Bulletin Date: 12/24/2014		Bulletin Effective Date: 12/24/2014	
Title: SPIL_QFN-4x4_Tray change			
Originator: Paranidharan Rengarajan		Phone: +65 6511 7735	Dept: Supplier Management
Customer Contact: Kathy Haggar		Phone: (512) 532-5261	Dept: Sales
Bulletin Details			
Description: Silicon Labs is pleased to announce a change is being made to the shipment media for Si53xx QFN-4x4 devices. Per the effective date of this PCN, there will be a change in tray supplier from Sunrise QJ-012 to Hwa Shu EAM040411. The tray dimensions for the current and new tray are identical, except the new tray’s cavity design and wall size have been optimized to prevent unit tilt and unit misplacement issues. Please refer to “Appendix A” for the comparison details between Sunrise QJ-012 & Hwa Shu EAM040411 trays. Refer to “Appendix B” for the tray drawings of both Sunrise QJ-012 & Hwa Shu EAM040411 trays.			
Reason: This change is being made to improve quality and operational efficiency.

Sunrise tray (QJ-012)

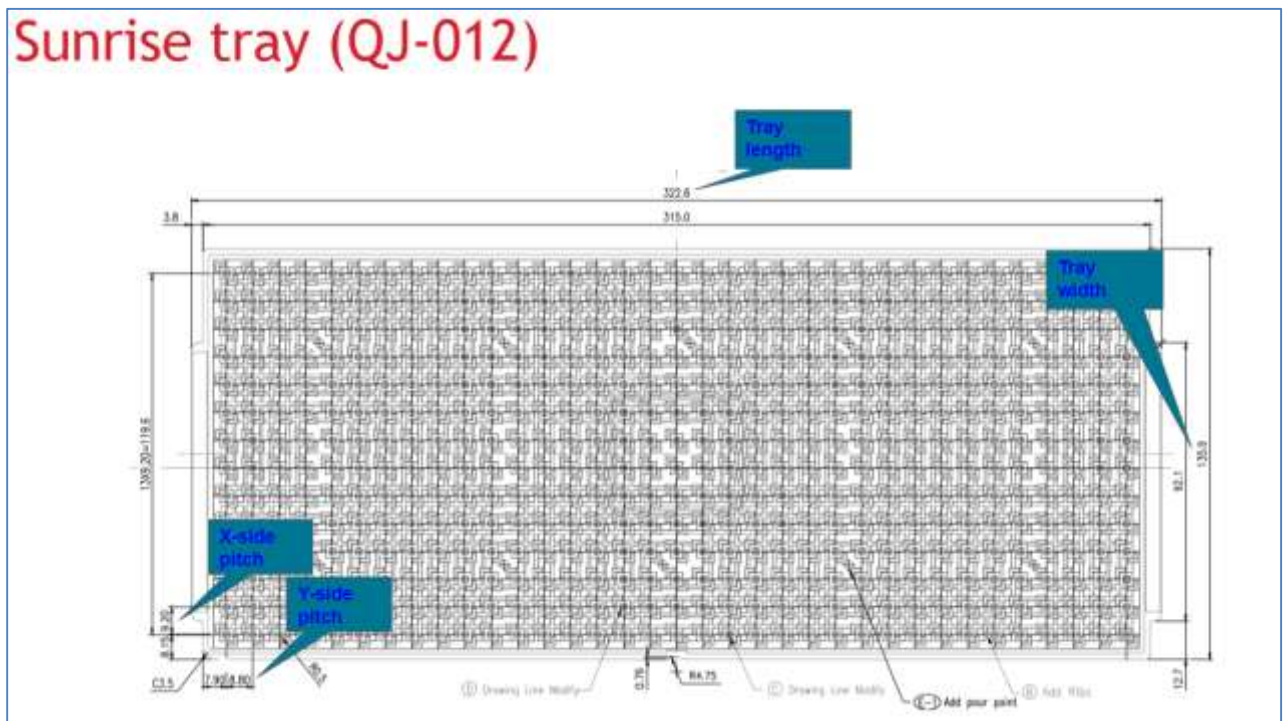
Sunrise and Hwa Shu tray out dimensions compare

Item	Sunrise tray (Tray drawing: QJ-012)	Hwa Shu tray (Tray drawing: EAM040411)	GAP
Tray Length	322.6mm	322.6mm	NO
Tray Width	135.9mm	135.9mm	NO
X-side pitch	9.20mm	9.20mm	NO
Y-side pitch	8.80mm	8.80mm	NO

Pocket Design & Dimension of Sunrise QJ-012 Tray (QFN-4x4):

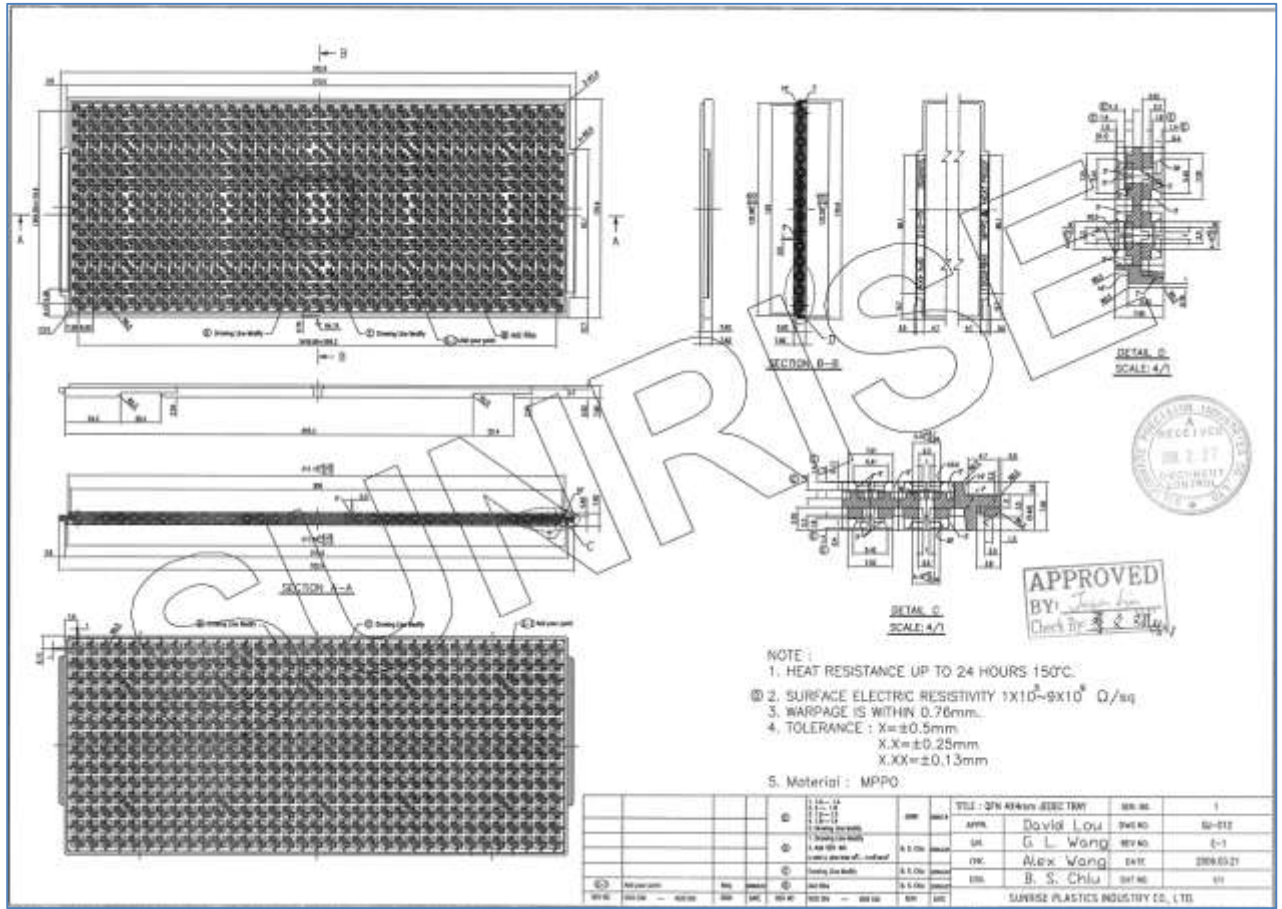
Sunrise and Hwa Shu tray cavity dimension compare

Remark : The color circle mean the tray key difference.

1. **Red**: IC sitting at IC cavity size
2. **Green**: tray top IC cavity wall size
3. **Blue**: tray bottom IC cavity wall size
